ADDENDUM NO. 5

REGIONAL PARK RESTROOMS
PROJECT NUMBER 122013

The following revisions to the Plans shall be made:

3 INTERIOR ELEVATIONS
SCALE: NOT TO SCALE

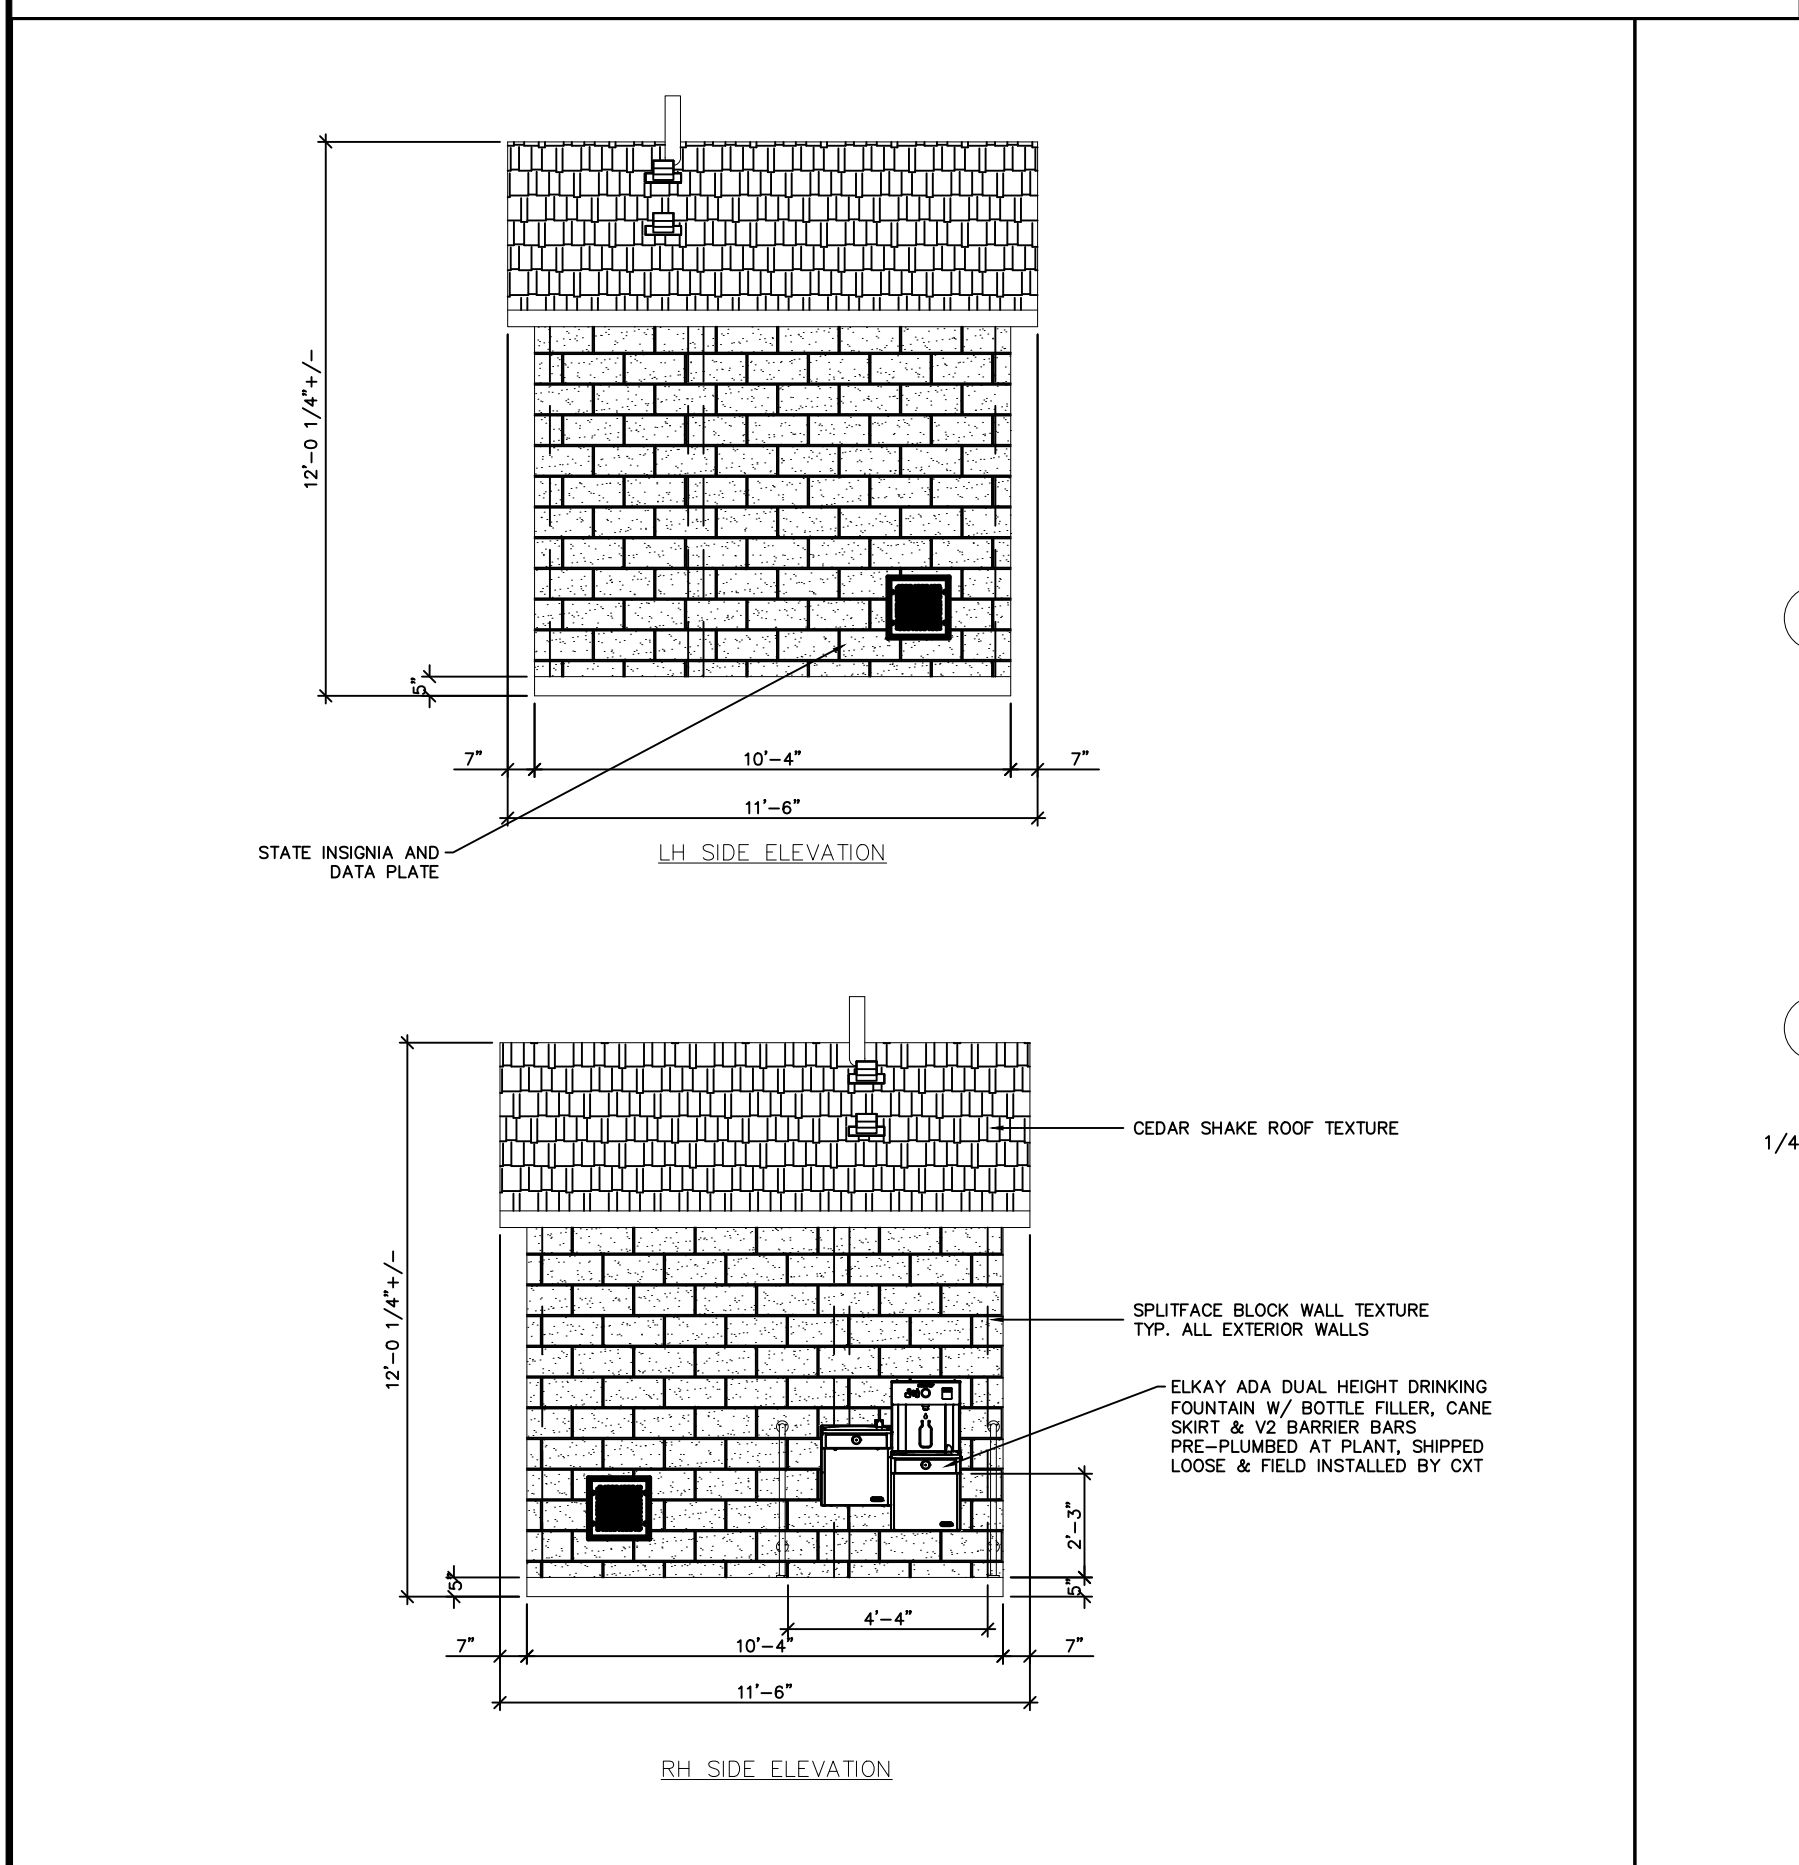
NO.	DATE	BY	REVISION MADE
1	2/22/2023	VM	Added cal trans verbage for sub base and aggregate base
